## PRODUCT CHANGE NOTIFICATION (PCN)

### AKSG-200/x Jumper Connector

CHANGE NOTIFICATION: PCN\_20220420\_AKSG200X

DESCRIPTION OF CHANGES: CHANGE OF PRODUCT LOCATION  
CHANGE OF DATA SHEET  
New Draw.-No.ASS\_0243\_COrev04

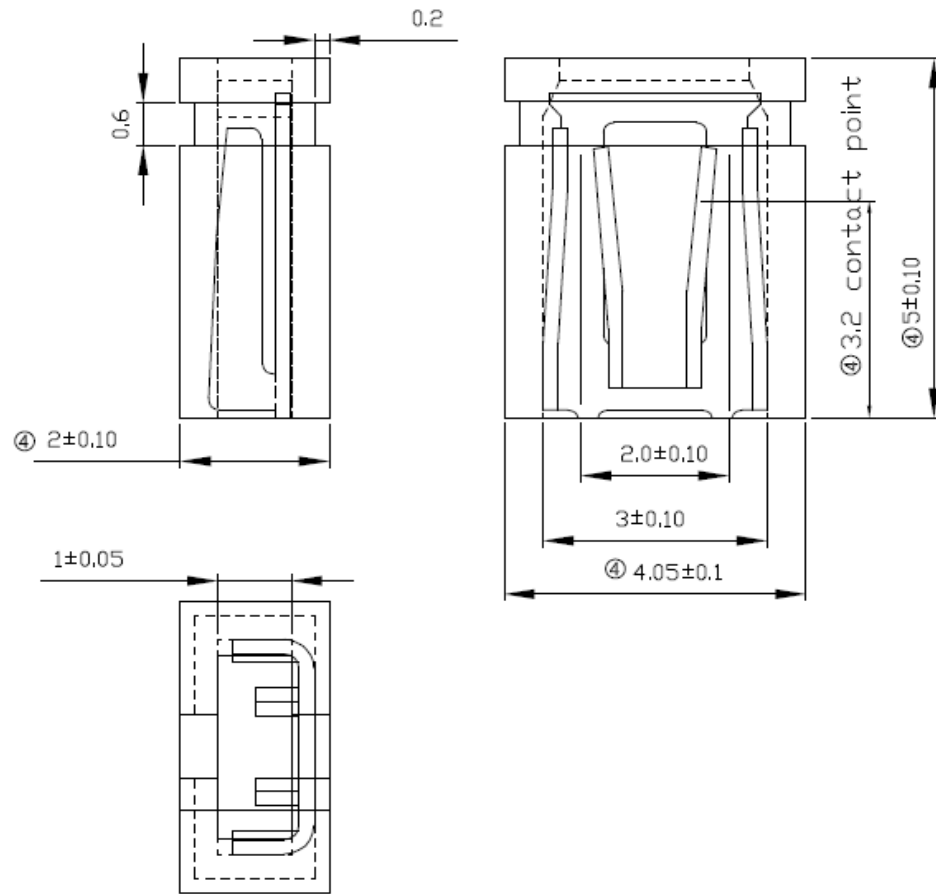
REASON FOR CHANGE: CHANGE OF PRODUCT LOCATION  
CHANGE OF PRODUCT DIMENSIONS, TOLERANCES AND/OR PROPERTIES

AKSG-200/x OLD VERSION	AKSG-200/G NEW VERSION																																				
<table border="1" style="margin-left: auto; margin-right: auto;"> <thead> <tr> <th>Scale</th> <th>Free</th> </tr> </thead> <tbody> <tr> <td colspan="2" style="text-align: center;">TOLERANCE</td> </tr> <tr> <td>.X</td> <td>±0.38</td> </tr> <tr> <td>.XX</td> <td>±0.25</td> </tr> <tr> <td>.XXX</td> <td>±0.13</td> </tr> <tr> <td>DIM</td> <td>TOL</td> </tr> <tr> <td>X.°</td> <td>±1°</td> </tr> <tr> <td>Angle</td> <td>TOL</td> </tr> <tr> <td>UNIT</td> <td>mm</td> </tr> </tbody> </table> <p><b>NOTES:</b></p> <ol style="list-style-type: none"> <li>1. Insulation: Glass Filled PBT, UL94V-0, Color Black</li> <li>2. Contact : Brass</li> <li>3. Current Rating: 3A Max</li> <li>4. Dielectric Voltage: 1000V rms / 1 minute</li> <li>5. Insulation Resistance: 1000M ohm Min.</li> <li>6. Contact Resistance: 30m ohm Max.</li> <li>7. Operating and Storage Temperature: -40°C ~ +105°C</li> <li>8. Mating Cycles: 10 Min.</li> </ol> <p style="text-align: center;">AKSG-200/x</p> <p style="text-align: center;">Contact Area Plating: ③  G: Gold Flash  Z: Tinned</p>	Scale	Free	TOLERANCE		.X	±0.38	.XX	±0.25	.XXX	±0.13	DIM	TOL	X.°	±1°	Angle	TOL	UNIT	mm	<table border="1" style="margin-left: auto; margin-right: auto;"> <thead> <tr> <th>Scale</th> <th>Free</th> </tr> </thead> <tbody> <tr> <td colspan="2" style="text-align: center;">TOLERANCE</td> </tr> <tr> <td>.X</td> <td>±0.38</td> </tr> <tr> <td>.XX</td> <td>±0.25</td> </tr> <tr> <td>.XXX</td> <td>±0.15</td> </tr> <tr> <td>DIM</td> <td>TOL</td> </tr> <tr> <td>X.°</td> <td>±1°</td> </tr> <tr> <td>Angle</td> <td>TOL</td> </tr> <tr> <td>UNIT</td> <td>mm</td> </tr> </tbody> </table> <p><b>NOTES:</b></p> <ol style="list-style-type: none"> <li>1. Insulation: Glass Filled PBT, UL94V-0, Color Black</li> <li>2. Contact : Brass</li> <li>3. Current Rating: 1.5 A Max</li> <li>4. Dielectric Voltage: 1000V rms / 1 minute</li> <li>5. Insulation Resistance: 1000M ohm Min.</li> <li>6. Contact Resistance: 30m ohm Max.</li> <li>7. Operating and Storage Temperature: -40°C ~ +105°C</li> <li>8. Mating Cycles: 10 Min.</li> </ol> <p style="text-align: center;">AKSG-200/x</p> <p style="text-align: center;">Contact Area Plating: ③  G: Gold Flash  Z: Tinned</p>	Scale	Free	TOLERANCE		.X	±0.38	.XX	±0.25	.XXX	±0.15	DIM	TOL	X.°	±1°	Angle	TOL	UNIT	mm

1. Insulation: Glass Filled PBT, UL94V-0, Color Black
2. Contact ; Brass
- ④ 3. Current Rating: 1.5 A Max
4. Dielectric Voltage: 1000V rms / 1 minute
5. Insulation Resistance: 1000M ohm Min.
6. Contact Resistance: 30m ohm Max.
7. Operating and Storage Temperature: -40°C ~ +105°C
- ③ 8. Mating Cycles: 10 Min.
